**CERTIFICATE OF APPROPRIATENESS**

**Property:** 1634 Arlington St, Lot 21, Block 114, Houston Heights Subdivision. The 6,600 square foot (50' x 132') interior lot is vacant.

**Proposal:** New Construction – Residence

**Recommendation:** Denial - does not satisfy criteria 1, 2, 3, or 4

**WEST ELEVATION – FRONT FACING ARLINGTON**

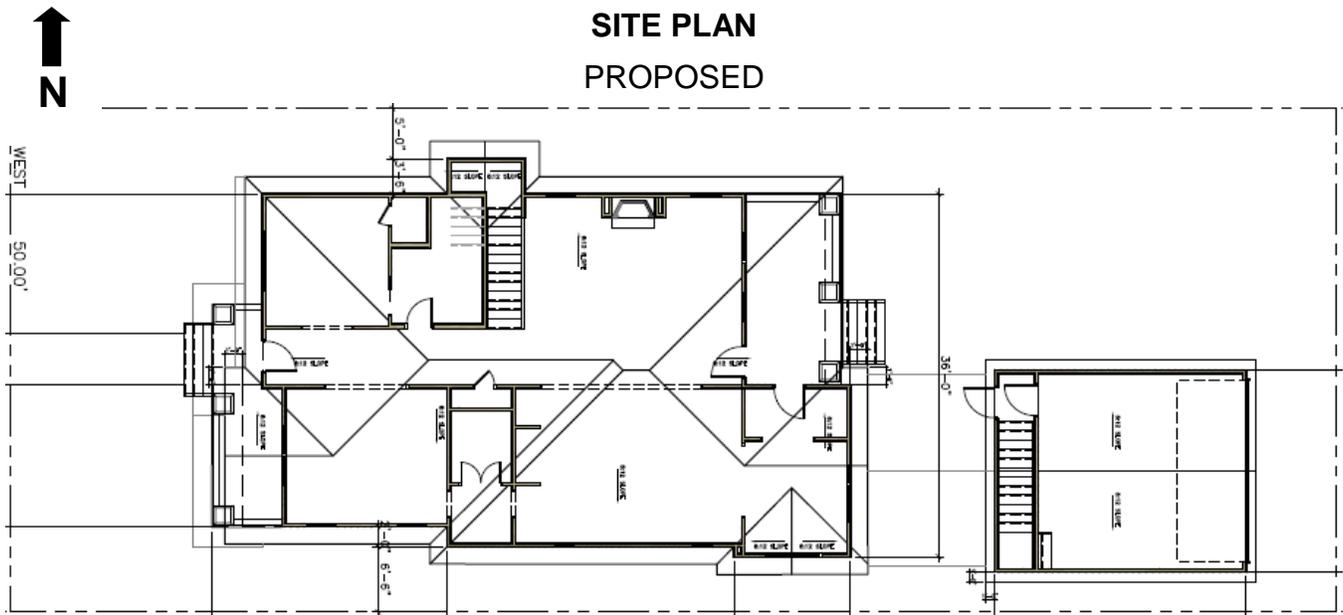
*The proposed house is located in a context area of only one-story contributing structures. The typical width of the contributing houses in this context area ranges from 24' to 30'. The proposed front wall width is 33' and maximum width is 39'.*

*The typical first floor plate height of contributing structures in the context area is 9'. The applicant has proposed a 10' first floor plate height and a 9' second floor plate height. The typical foundation height of contributing structures in the context area is 24". The applicant has proposed a 32" foundation height, which is not compatible with this context area.*

*If the applicant reduces the width of the front section of the house to no more than 30', reduces the first and second floor plate heights to no more than 9', and changes the proposed foundation height to 24", staff believes the house would then satisfy Criterion 4(a). Reducing the foundation and first floor plate height will also lower the proposed porch eave height (11'-9") to a height that is compatible with the context area.*

3. The front façade massing of the proposed structure is not compatible with that of existing contributing structures in the context area. The proposed front (west facing) façade should be simple in design and not have multiple gables. Additionally, the window height of width to height (should be taller than wide) is not compatible in some proposed locations on the side of the structure.

4. The frontal mass of the first and second story on the proposed west facing façade is not compatible with existing contributing structures in the context area. The forward placement of the second story over the first story porch adds to the frontal mass that is not compatible with existing contributing structures in the context area and does not allow a visual scale reduction from two story to one story on the first floor which is the typical visual character of structures in the context area.

5. The width of the proposed structure at the front side is not compatible with the that of existing contributing structures in the context area. By incorporating the comment made in #2 above regarding side setbacks, the resulting building width will become compatible.

6. The proposed first floor height of the structure is not compatible with that of existing contributing structures in the context area and should be reduced to a compatible height. This non-compatible first floor height contributes to the non-compatible overall structure height.

**SANBORN MAP – 1600 BLOCK OF ARLINGTON**  
**SETBACKS**

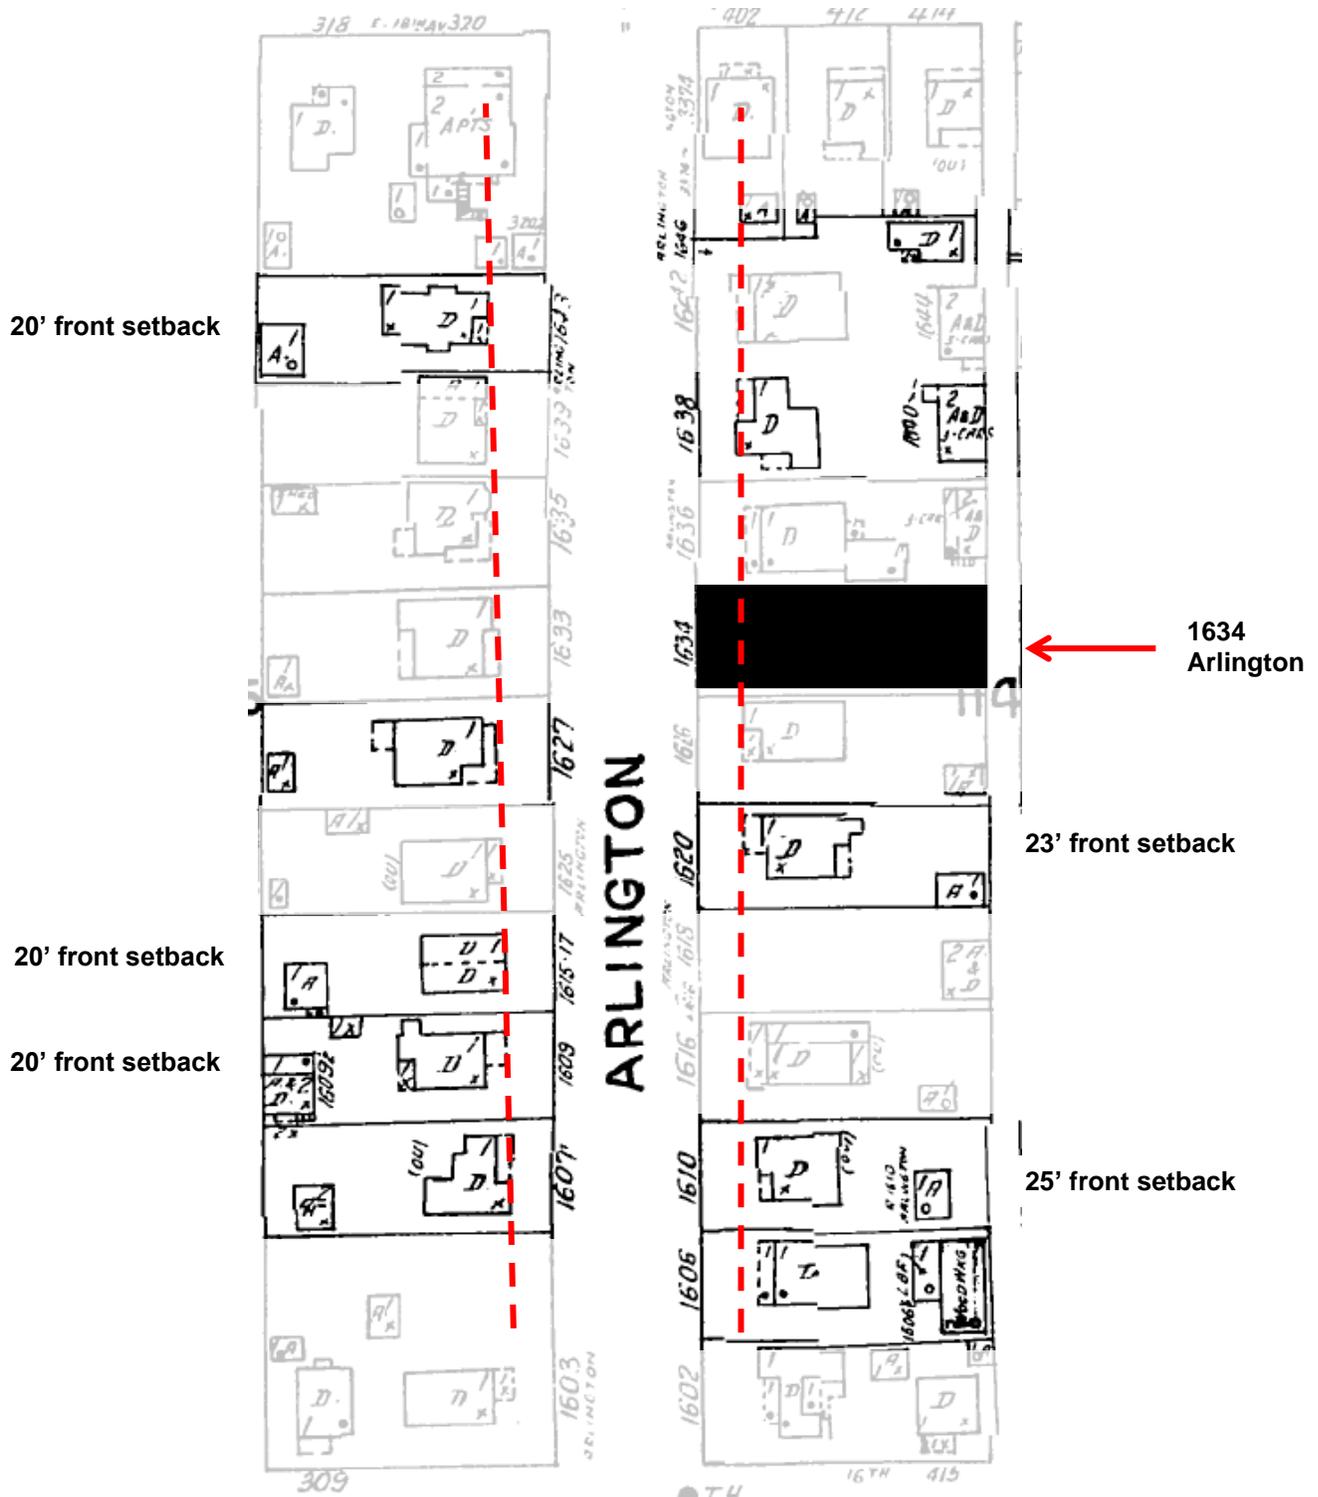
1. The indicated front setback for the proposed covered porch is 15 feet as shown on the application (a 20 feet deep front setback is indicated in the text but that is to the front of the first floor structure and is not the typical measuring point when a covered porch is indicated. The front setback of the porch is the governing measurement). This setback is not compatible with the context area of existing contributing structures. A deeper front setback is required to be compatible with the context area of the same blockface and the opposing blockface.

2. The proposed side setbacks are not compatible with the side setbacks of existing contributing structures in the context area. The typical and prevailing side setbacks in the context area are between 7 feet on one side and 15 feet on the other side. The proposed structure should match these contributing structure side setbacks.
